UNITED STATES PATENT AND TRADEMARK OFFICE

APPLICATION NO.	FILING DATE	FIRST NAMED INVENTOR	ATTORNEY DOCKET NO.	CONFIRMATION NO.
10/552,390	05/30/2006	Neil Russell Foster	MAP1130	4759
28213	7590	07/06/2011	EXAMINER	
DLA PIPER LLP (US) 4365 EXECUTIVE DRIVE SUITE 1100 SAN DIEGO, CA 92121-2133			ZALASKY, KATHERINE M	
			ART UNIT	PAPER NUMBER
			1777	
			MAIL DATE	DELIVERY MODE
			07/06/2011	PAPER

Office Action Summary

DETAILED ACTION

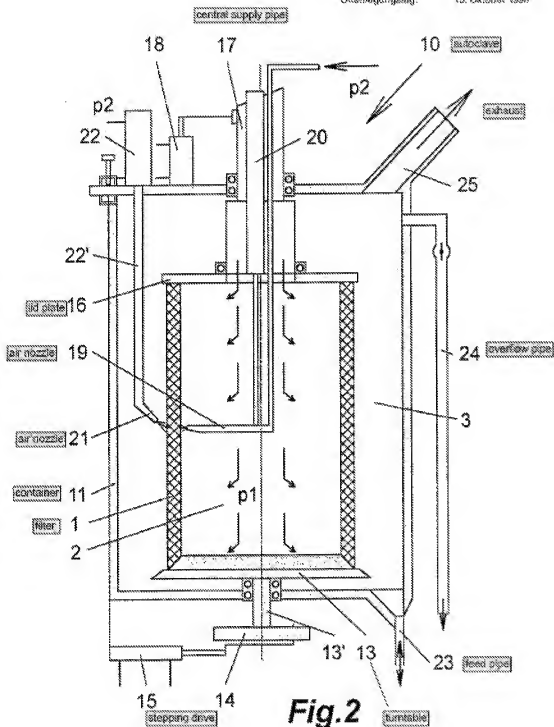
an outer chamber for containing a dense gas, wherein the outer chamber is an autoclave (Figure 2, autoclave 10, container 11);

an inlet for supplying dense gas as a solvent, wherein the inlet is configured such that the dense gas is introduced through a straight shaft and delivered to the center of the apparatus (inlet 23, inlet nozzle 19, inlet nozzle 21);

a porous chamber within the outer chamber for containing a substance for dissolution or suspension with the solvent, the porous chamber having a wall which allows passage of solvent and the substance dissolved or suspended in the solvent (filter 1), and

an outlet for removing solvent and solution and/or dispersion from the outer chamber (exhaust 25, overflow pipe 24) and a turbulence means for creating turbulence within the porous chamber, wherein the turbulence creating means comprises a drive means to rotate the porous chamber within the outer chamber (turntable 13, stepping drive 14, 15).

Regarding **claim 2**, Mertens discloses the apparatus wherein the inlet in the outer chamber supplies solvent directly to a mouth communicating with the porous chamber (air nozzle 19).

Regarding **claim 3**, Mertens discloses the apparatus wherein the inlet is in the wall of the outer chamber (inlet 23).

Regarding **claim 4**, Mertens discloses the apparatus wherein the inlet supplies solvent to the porous chamber and the region between the porous chamber and the outer chamber (air nozzle 21).

Regarding **claim 5**, Mertens discloses the apparatus wherein the porous chamber is further provided with a longitudinally extending shaft communicating with the solvent inlet of the porous chamber (air nozzle 19, shaft extending into the porous chamber with inlet opening at end).

Regarding **claim 6**, Mertens discloses the apparatus wherein the shaft is porous or perforated (air nozzle 19, shaft extending into the porous chamber with inlet opening at end, thus it is porous).

Regarding **claim 7**, Mertens discloses the apparatus wherein the porous chamber is adapted to receive the substance in the region around the longitudinally extending shaft and the porous chamber is adapted to receive solvent through the shaft (Figure 2, air nozzle 21, air nozzle 19, inlet 23).

Regarding **claim 11**, Mertens discloses the apparatus wherein the porous chamber is provided with a plug to hold the substance against the base of the inner chamber (Figure 2, lower end of filter unit is solid).

Inlet nozzle 19 of Mertens introduces fluid into the chamber with a straight shaft; the shaft has two straight sections, a horizontal section and a vertical section. Alternatively, as presented above, feed pipe 23 may also be interpreted as the inlet. Pipe 23 is a straight shaft. Both inlets are capable of delivering fluid to the center of the chamber (even if not directly aimed toward the center, circulation in the chamber will allow the fluid to reach the center of the chamber).
